HP PERMIT NUMBER: HP-0712-2025

PROPERTY ADDRESS: 1131 East 19th Street

A. CASE ITEMS FOR CONSIDERATION

HP PERMIT NUMBER: HP-0713-2025

Current Exterior Condition of Windows

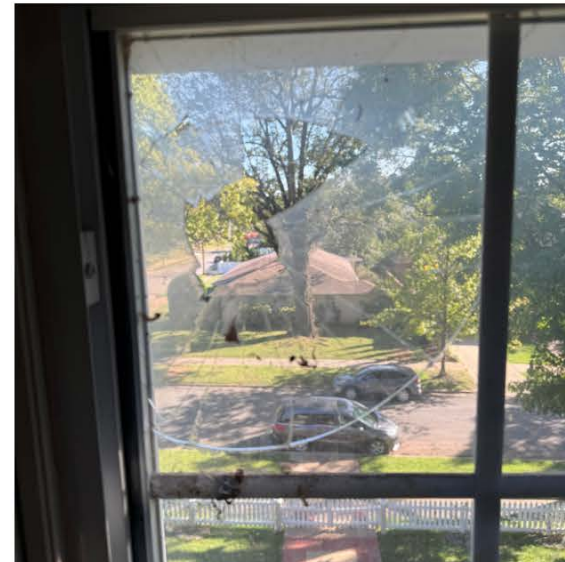
1. The applicant proposes the replacement of 19 builder-grade aluminum windows with vinyl grills between glass in between. The proposed replacement windows are wood composite by Renewal by Anderson. The subcommittee recommended approval at the October 9th, 2025 meeting.

Damage includes cracking plastic
vinyl and broken glass and panels

Front Soffit
432 x 50 11

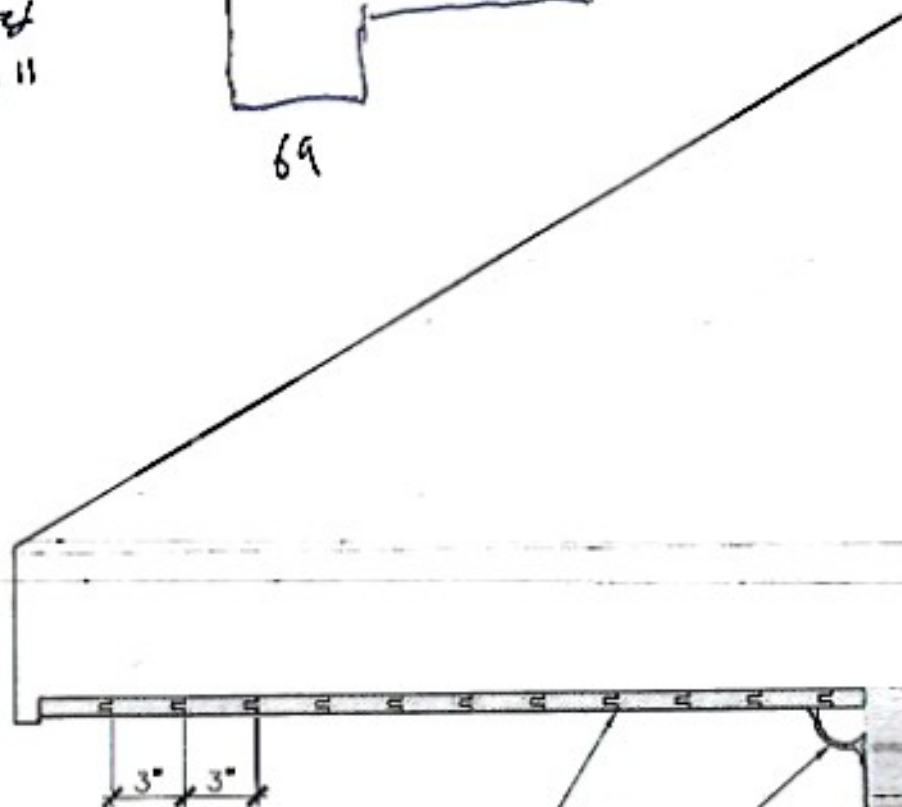
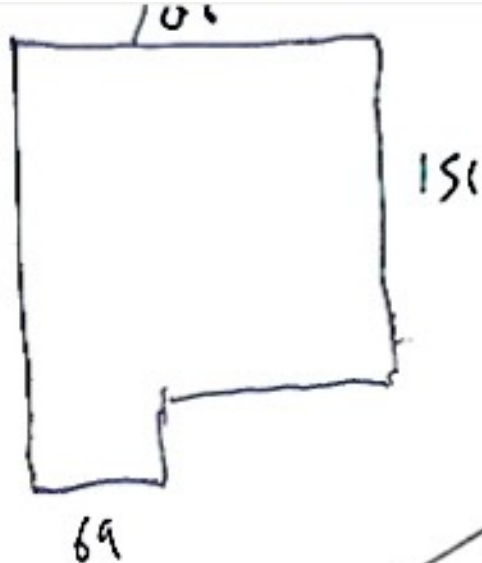
The applicant proposes to replace the soffit with 3” tongue and groove boards. The site plan with dimensions is attached to the staff report.

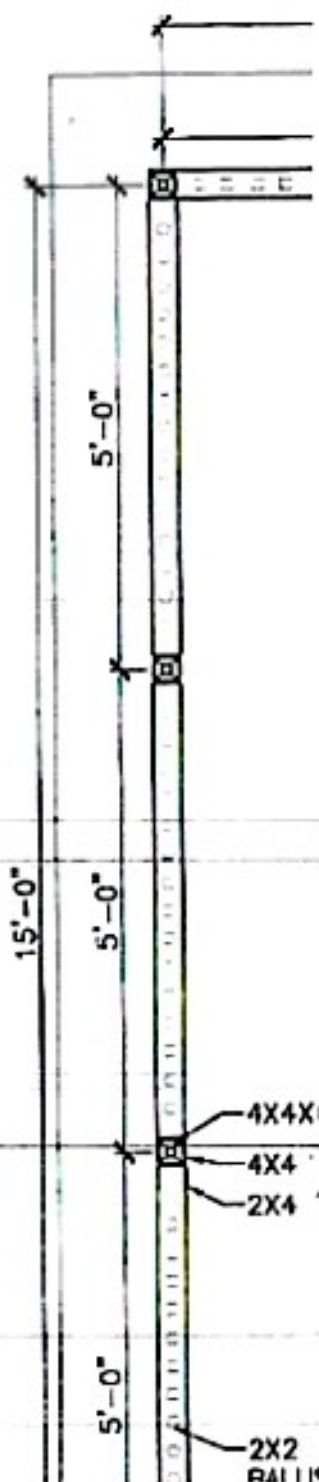
TRIM SOFFIT BOARDS,
INSTALLED PARALLEL TO
THE FACADE, PAINT TO
MATCH TRIM.

CORNICE MOLDING, PAINT
TO MATCH TRIM.
